SUBJECT: Campaign #108 – DRL Module Ground Wire

INSTRUCTION TO PERFORM CAMPAIGN #108

INSTRUCTIONS TO PERFORM CAMPAIGN 108

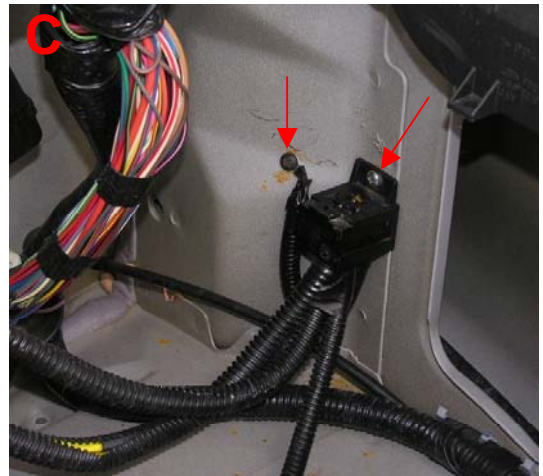
The procedure involves replacing the ground wire in the housing that receives the DRL module.

1. Open front hood.
2. Disconnect negative battery cable from chassis battery.
3. Remove 3 mounting screws on the engine coolant reservoir. Leave all hoses attached and set reservoir aside. See Photo A.

4. Unplug DRL module. See Photo B.

5. Remove ground wire screw on the inner fender. Remove screw holding housing that receives the DRL module to the inner fender. See Photo C.

6. Remove ground wire from the housing that receives the DRL module using a small screwdriver to release the locking tab. See Photos D and E.

7. Insert new white ground wire. See Photo F.

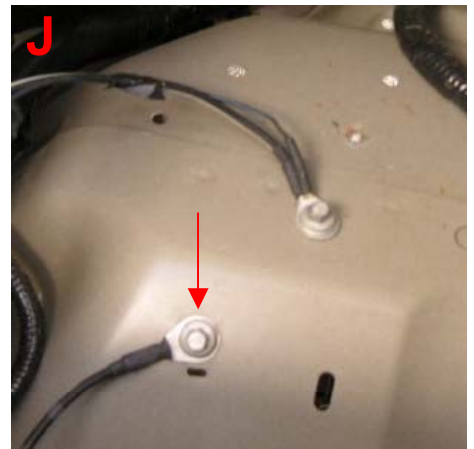
10. Remove fuse panel covers and disconnect old power wire from stud using a 10 mm socket. Install new power wire to stud. See Photo H.

11. Engage new black power wire (with fuse holder) to housing that receives the DRL module in the same manner as described in Step 7.

12. Reinstall fuse covers. See Photo I.

13. Install ground wire to the ground bolt that has only one wire. See Photo J.
